COMPANY: YC3102 EVB V1.0			
		TITLE:			
DESIGN:	DATED: 2019-05-15				
REVISION:		CODE:	SIZE:	DRAWING NO:	REV:
QUALITY CONTROL:	DATED:	E			
RELEASED:	DATED:				
		SCALE:		SHEET: 1 of 1

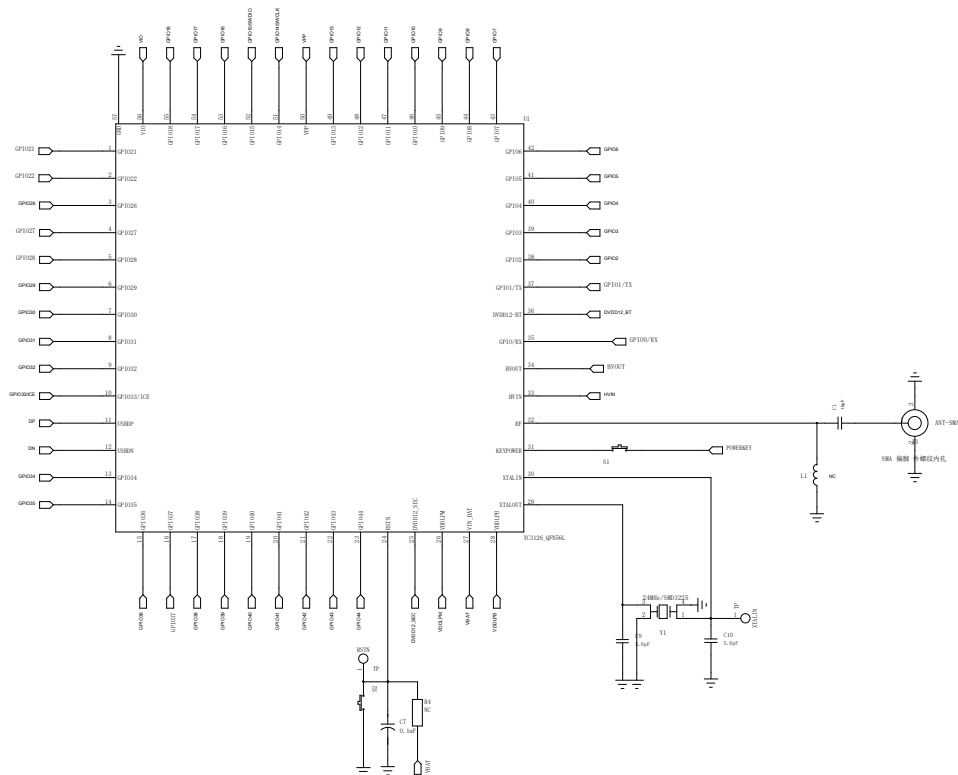
问题1、PCB上P4和J1的间距过小

问题2、PCB上添加CELL_BAT测电流端子
